August 16, 2023

**RE: 90 Circuit Avenue, Bourne (Pocasset), MA
Supplemental Information for Septic System Local Upgrade Application**

Photograph of House Floor Plan, provided by homeowner

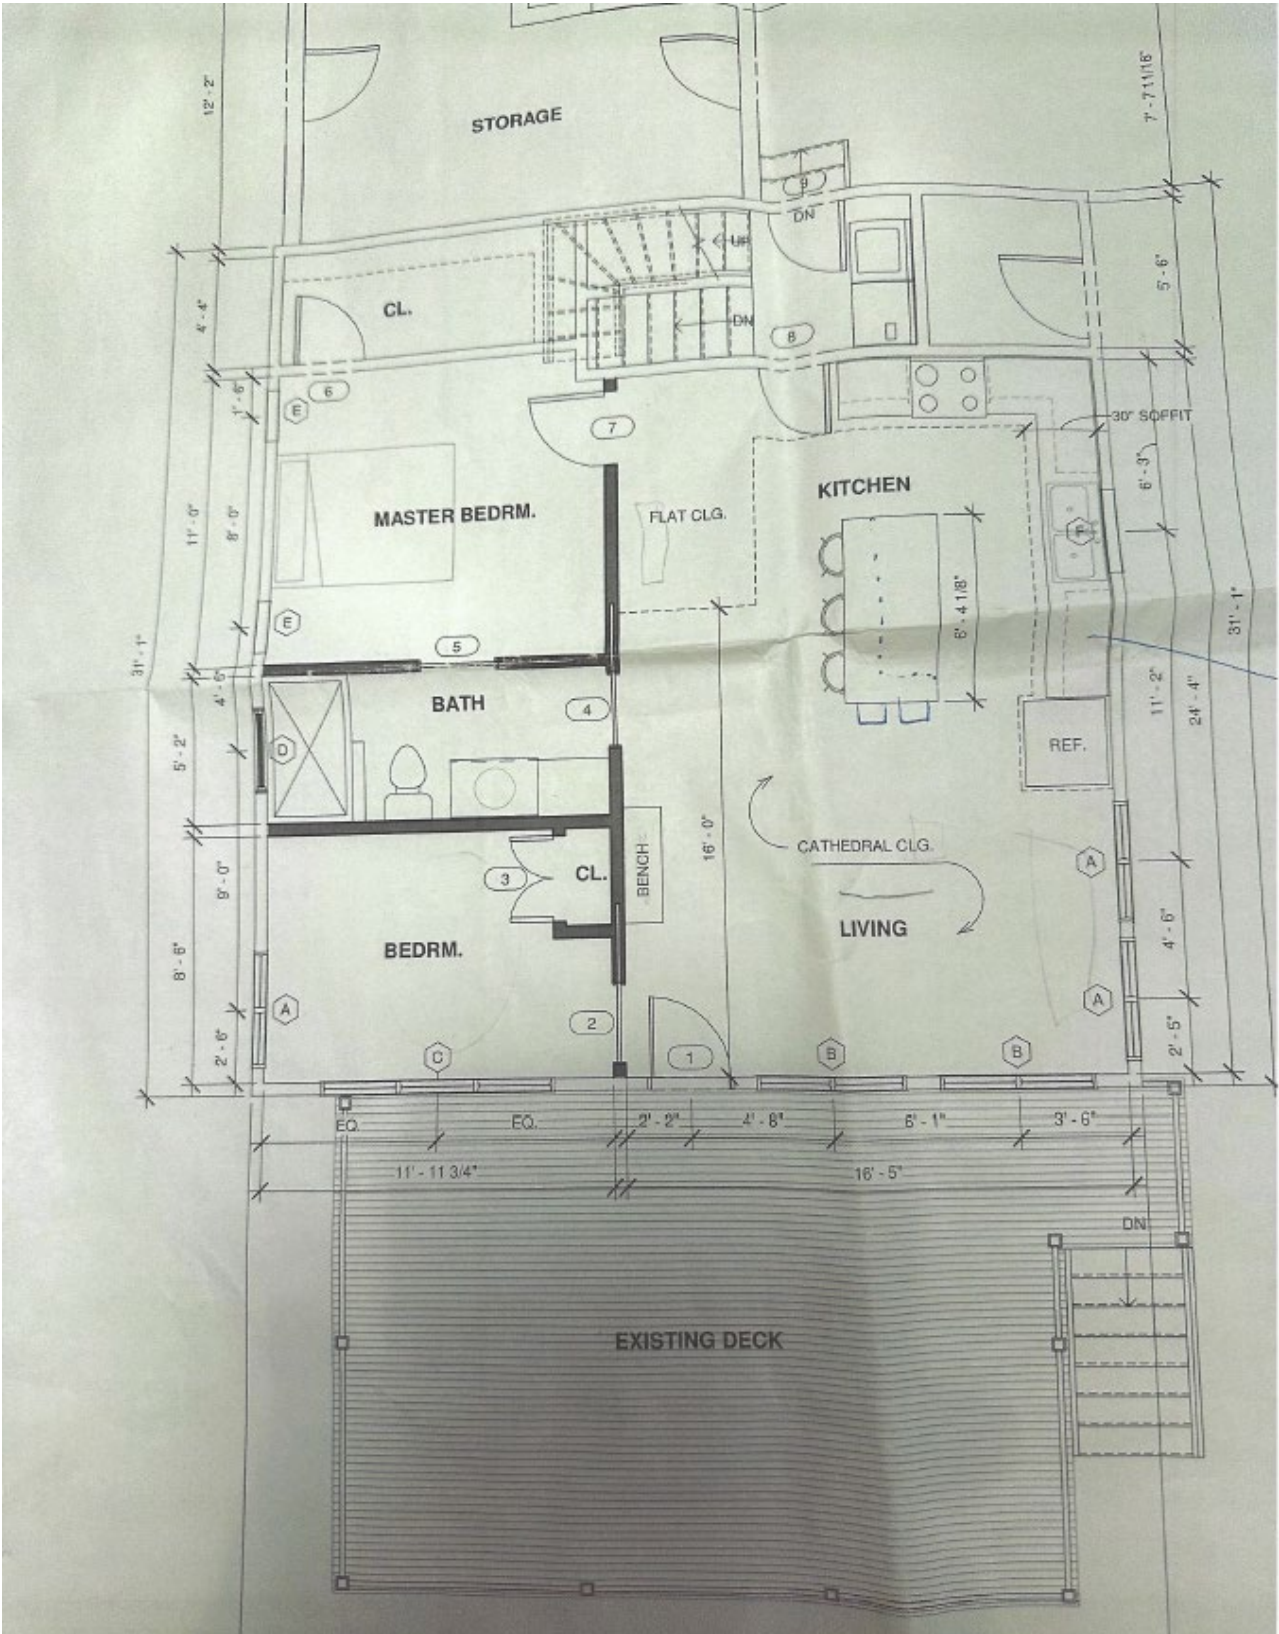
First, the original Board of Health application for this project did not include a floor plan of the existing dwelling. The facility is a two-bedroom single family dwelling and it is restricted as a two-bedroom through a Title 5 Bedroom Count Deed Restriction endorsed in August 2017 and recorded at the registry of deeds under Book 30669 Page 290, and made part of the original application filing. Furthermore, the applicant found a floor plan of the dwelling and provided a photograph of such enclosed at the end of this letter.
